Airworthiness Directive Gliders      GFA/R.Schneider/1/74

Lemke/Schneider LS-1.

74-96 Rolladen Schneider

74-70 Rolladen Schneider

Skizze  
Sketch (A)

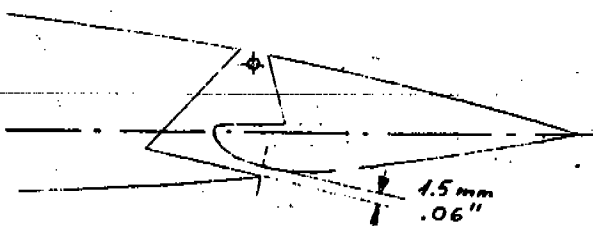
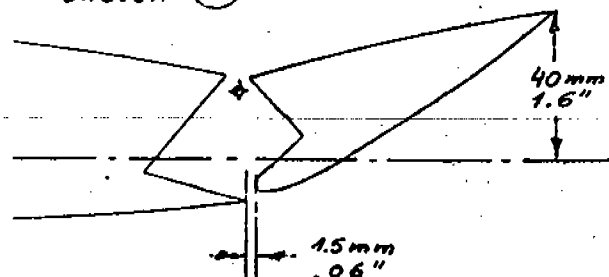
Owing to inaccuracy or warp the upwards deflected aileron can be blocked by the lower seal of the aileron slot if the wing is exposed to negative loads.

1. Check of aileron-gap with aileron in neutral position:  
The vertical distance between the lower seal of the aileron slot and lower aileron lip (Dimension according to sketch (A) must at no place be smaller than 1.5 mm (0.06 inch).
2. Check of aileron-gap with aileron deflected upwards 40 mm (1.6 inch):  
The horizontal distance between the lower seal of the aileron slot and aileron-leading-edge (Dimension according to sketch (B) must at no place be smaller than 1.5 mm (0.06 inch).
3. If at any place a smaller distance is found, the accurate distance as given above, are to be established by grinding or shortening of the lower seal of the aileron slot.

It is recommended to check the dimension of the gap by inserting a small plate of 1.5 mm (0.06 inch) thickness.
